**ZONING AMENDMENT &  
SUBDIVISION STAFF REPORT****Date: April 2, 2015****APPLICANT NAME**

Pender Ridge Subdivision

Rezoning from R-1, Single-Family Residential District, R-2, Two-Family Residential District, and B-2, Neighborhood Business District, to B-5, Office-Distribution District, to allow a heavy equipment storage facility and Subdivision approval to create four (4) legal lots of record.

# SITE PLAN

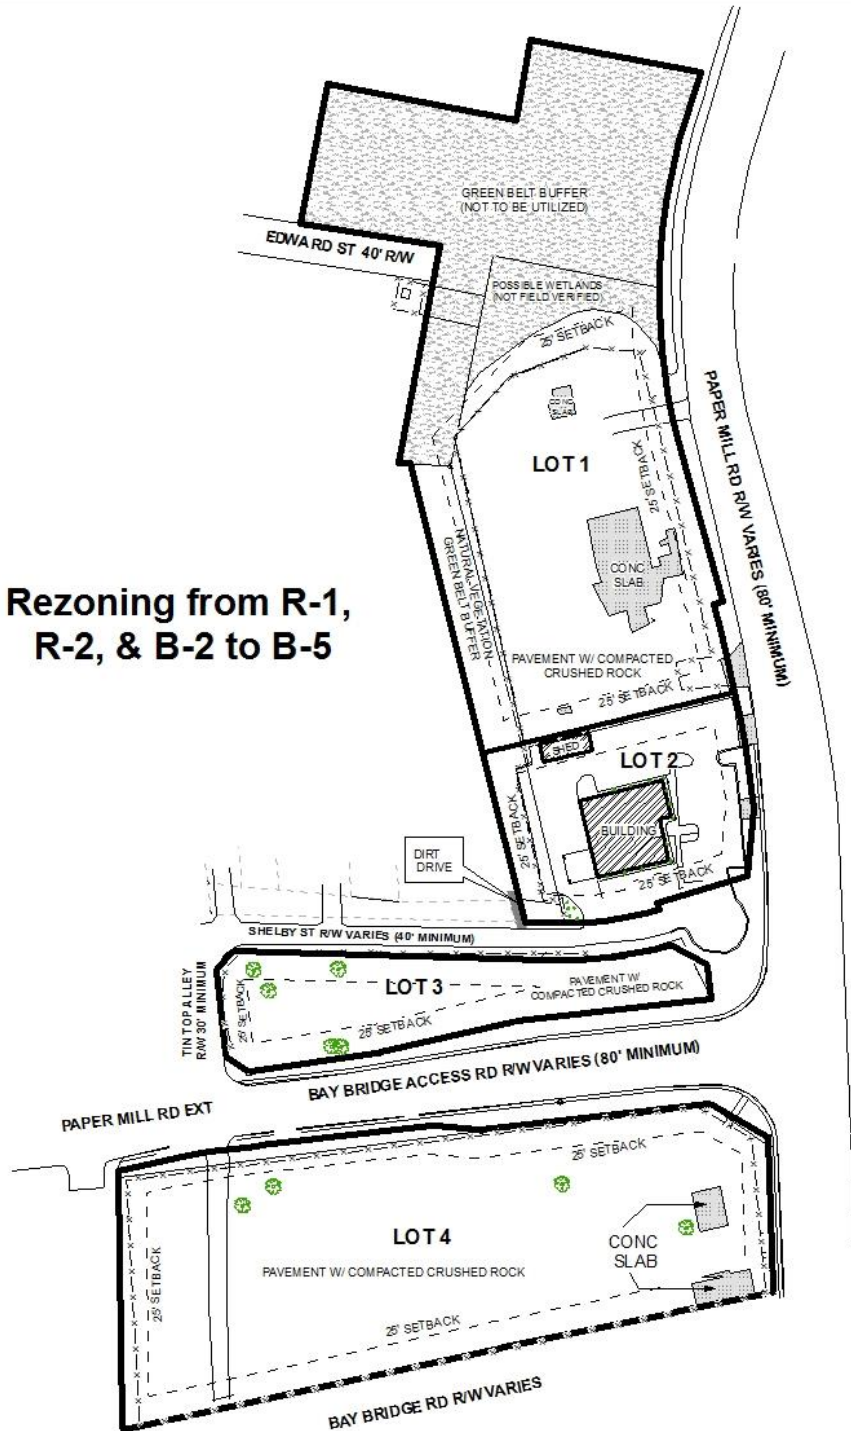
It should be pointed out that the site plan depicts crushed rock surfacing on the proposed Lots 1, 3, and 4. It appears that gravel surfacing was added to Lot 1 recently, without any permits or approvals, based upon a recent site visit initiated by a citizen complaint. Recent photos also show a new chain-link fence with barbed wire that also appears to have been installed without permits. Gravel surfacing is only allowed by right in I-1 and I-2 districts, and therefore, a variance from the Board of Zoning Adjustment will be required to allow the use of gravel for parking; otherwise, a paved parking surface will be required if the variance is not approved. A building permit for new fencing and approval by the Director of the Urban Development Department will be required for the barbed wire fencing.

The site plan depicts several large oak trees. Although dimensions are not depicted, the removal of any Live Oak tree greater than 24" will require a Tree Removal Permit.

No proposed sidewalks are illustrated on the site plan. Any future commercial use of the proposed lots will necessitate the installation of a sidewalk, or an application for a waiver may be submitted.

In accordance with the Subdivision Regulations, all 4 proposed lots are compliant with the minimum size requirements; however, Lots 3 and 4 will require a waiver of Section V.D.8. of the Subdivision Regulations due to frontage along multiple streets. The lot size is listed in acres on the plat and should be retained on the Final Plat, if approved.

As mentioned, the site has frontage along multiple streets: Bay Bridge and Paper Mill Roads, Paper Mill Road Extension, Edwards and Shelby Streets, Tin Top Aly, and Peace and Wiley Lanes. The right-of-way widths are depicted as variable; however, the minimum right-of-way should be depicted, per Section IV.A.2.d. of the Subdivision Regulations, and so that Staff can determine if the existing right-of-way widths are sufficient. It should be pointed out that the unopened right-of-way of Wiley Lane is not depicted but should be illustrated on the revised plat.

The 25' minimum building setback line is not illustrated on the plat and should be depicted along all road frontages and street stubs on the Final Plat, if approved.

It should be pointed out that there is an underground pipeline that runs through the site which indicates there is an easement not shown on the preliminary plat. As such, if necessary, the Final Plat should be revised to illustrate all easements along with a note stating no permanent structure can be placed or erected within any easement, if approved.

*It appears the applicant proposes a 30' minimum building setback in lieu of the required 25' minimum building setback. The 30' setback is depicted on the plat; however, given the fact that the site abuts multiple streets, this setback does not appear along all road frontages. As such, the Final Plat should be revised to illustrate a minimum of at least a 25' minimum building setback line along all road frontages, to include Edwards Street and Wiley Lane, if approved. The minimum right-of-way width of Peace Lane, which is located along the western lot line of the proposed Lot 4, should also be illustrated on the Final Plat – with the provision of dedication sufficient to provide 30' from centerline, if necessary - if approved.*

*A 50' Plains Pipeline L.P. easement is depicted within the eastern portion of the proposed Lot 1 along Paper Mill Road. If approved, a note should be placed on the Final Plat stating that no permanent structure(s) can be placed or constructed within any easement.*

***Subdivision:** With a waiver of Section V.D.8. of the Subdivision Regulations, the application is recommended for tentative approval, subject to the following conditions:*

- 1) Dedication, sufficient to provide 30', as measured from the centerline of Tip Top Aly and Shelby Street for Lots 2 and 3;*
- 2) Revision of the lot size information and 30' minimum building setback line to reflect dedication;*

- 3) Placement of a note on the Final Plat stating: (No permanent structure(s) can be placed or constructed in any easement);*
- 4) Retention of the lot size information and 25' minimum building setback line on the Final Plat;*
